**MONTGOMERY COUNTY HISTORIC PRESERVATION COMMISSION**  
**STAFF REPORT**

<b>Address:</b>	9910 Capitol View Ave., Silver Spring	<b>Meeting Date:</b>	11/17/2021
<b>Resource:</b>	1935+ (Non-Contributing) <b>Capitol View Park Historic District</b>	<b>Report Date:</b>	11/10/2021
<b>Applicant:</b>	Kijana & Tracyann Mburu	<b>Public Notice:</b>	11/3/2021
<b>Review:</b>	HAWP	<b>Tax Credit:</b>	No
<b>Case No.:</b>	969273	<b>Staff:</b>	Dan Bruechert
<b>PROPOSAL:</b> Partial Demolition, Building Addition, and construction of a Deck

## **PROPOSAL**

A001 PLAN ELEV

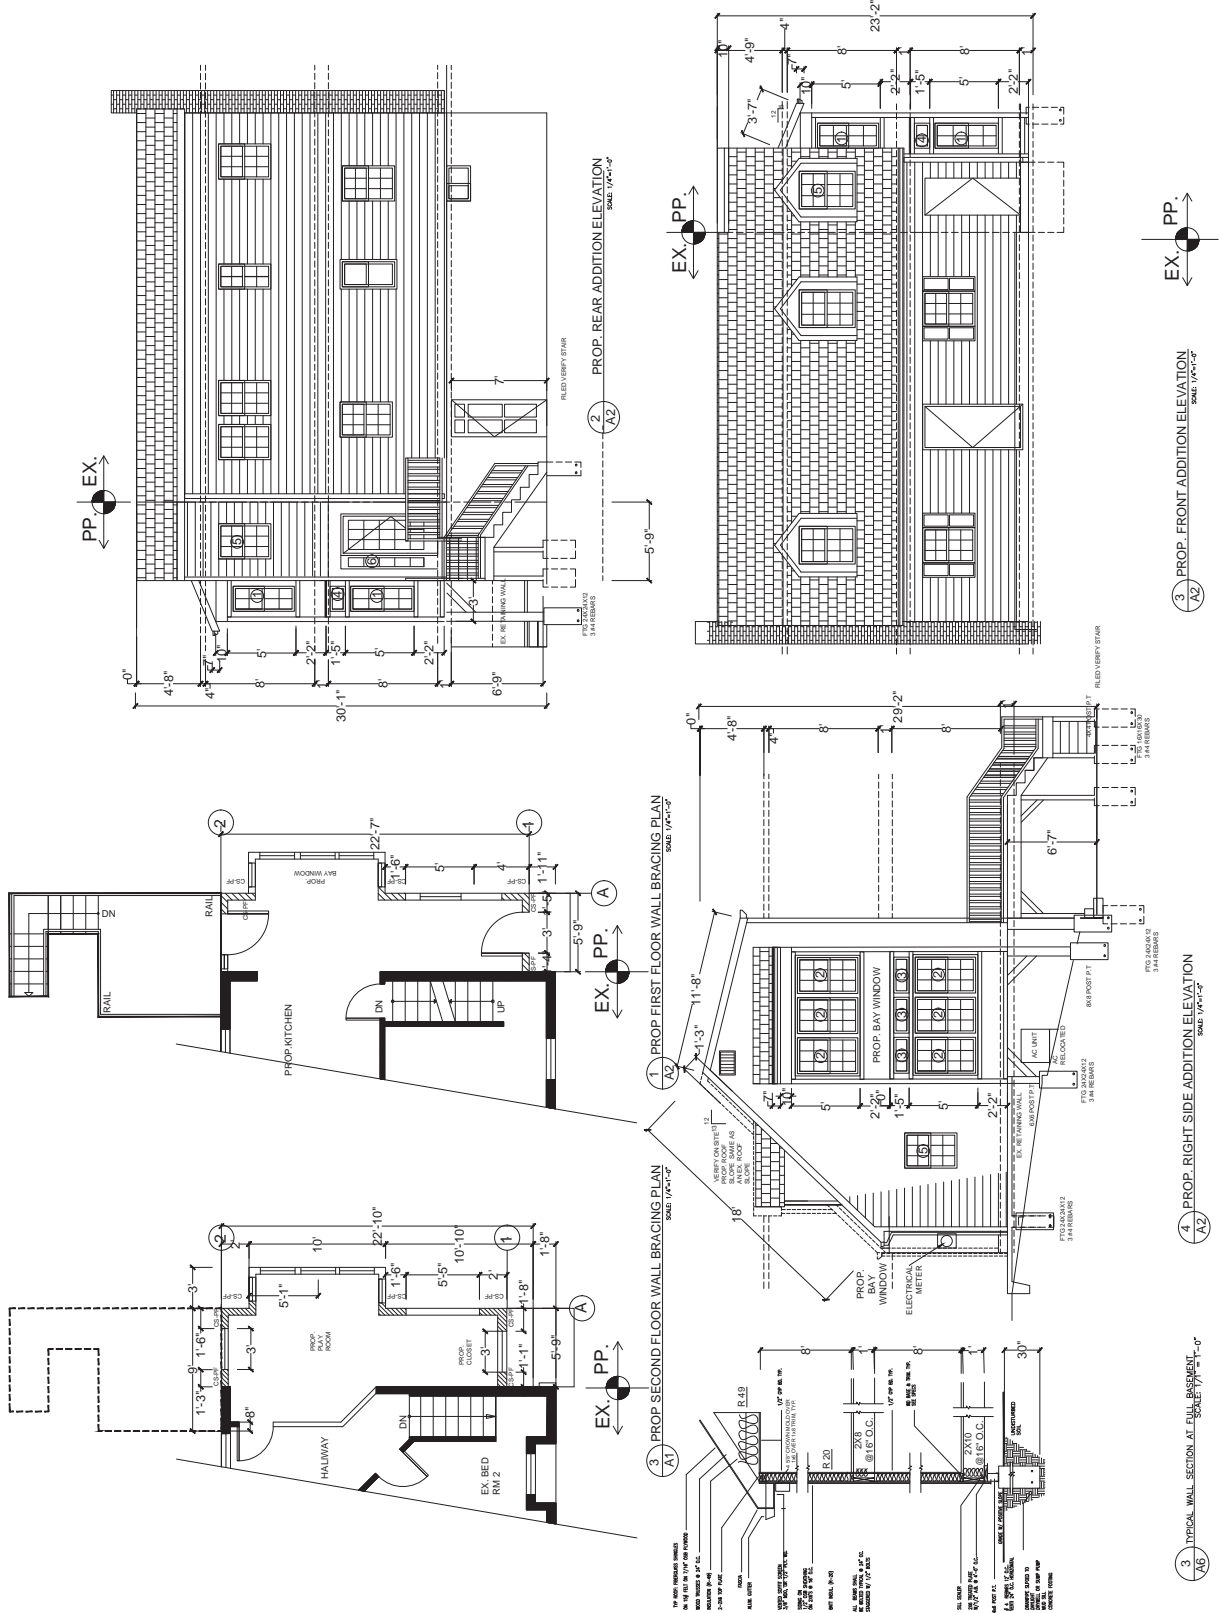
The proposed addition follows the form, materials, and architectural details of the existing house, with a side rectangular bay topped by a shed roof. One front-facing dormer will be installed on the addition. The proposed addition will be set back from the front wall plane by 1' 11" (one foot, eleven inches) with a roof ridge 1' 3" (one foot, three inches) lower than the existing roof ridge. The proposed addition, including the proposed bay, projects 7' 3" (seven feet, three inches) from the existing wall plane.

Staff finds that side additions to resources to considered 'Contributing' or 'Outstanding' are generally disfavored due to their impact on the massing of the historic resources. In this instance, the subject property does not contribute to the historic character of the district and its importance is that it reinforces the general settlement pattern and forms found throughout the district. Also of note, this section of the district was developed after the identified periods of significance for the district, with three houses to the north of the subject property constructed in 1946 and the house to the south was constructed in 1994. Staff finds the form of the addition is compatible with the house and will not detract from the character of the district as a whole.

Staff finds that the materials selected for the addition including vinyl siding, vinyl windows, and fiberglass doors would not generally be appropriate for buildings in the Capitol View Historic District constructed before 1935. However, the proposed materials are all consistent with the existing materials on the house and, Staff finds, will visually blend in with the existing construction. Staff finds requiring typical materials for new construction (i.e. fiber cement siding, clad windows and doors) would result in an incongruous appearance that would stand out from the surrounding district. Staff finds the proposed materials are appropriate for the subject property.

At the rear of the proposed addition, the applicant proposes constructing a wood deck. The deck will be approximately 9' (nine feet) square with wooden stairs that project to the rear. Staff finds this feature will not be visible from the right-of-way, is an appropriate material and, because this is a non-contributing resource, should be approved as a matter of course.

Staff recommends that the Commission **approve** the HAWP application under the Criteria for Issuance in Chapter 24A-8(b)(2) and (d), having found that the proposal will not substantially alter the exterior features of the historic resource and is compatible in character with the district and the purposes of Chapter 24A;
